SUBJECT: ISSUANCE OF AMENDMENTS - VOGTLE NUCLEAR GENERATING PLANT, UNITS 1 AND 2 (TAC Nos. M82985 AND M82986)

SUBJECT: ISSUANCE OF AMENDMENTS - VOGTLE ELECTRIC GENERATING PLANT, UNITS 1 AND 2 (TAC Nos. M82985 AND M82986)

Amendment No. 55 License No. NPF-68

Amendment No. 34 License No. NPF-81

Figure 5.1-2 Effluent Release Points

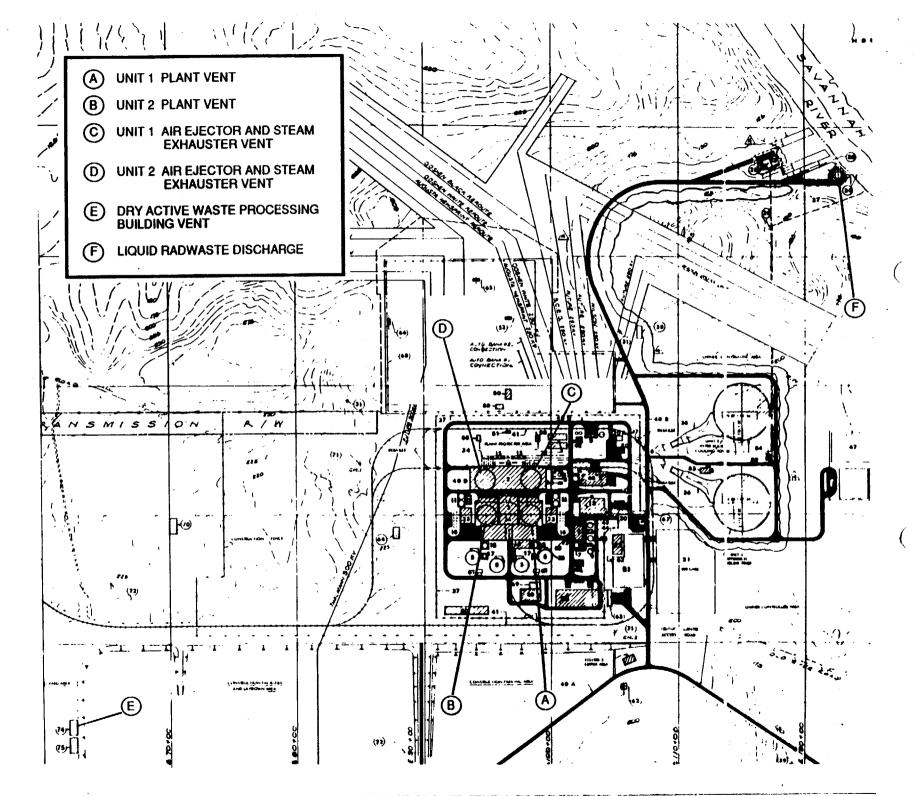
#### 2.3 Changes to Correct TS Figure 5.1-2

The proposed change to correct TS Figure 5.1-2 would delete the "Radwaste Solidification Building Vent" (which does not exist) and would replace it with the "Dry Active Waste Processing Building Vent."

The NRC staff finds that this correction to Figure 5.1-2 is consistent with actual plant design as accepted by the NRC in February 1989 (see Vogtle Supplemental Safety Evaluation Report No. 8, pp 11-4, 11-5, and 11-6). The change is, therefore, acceptable.
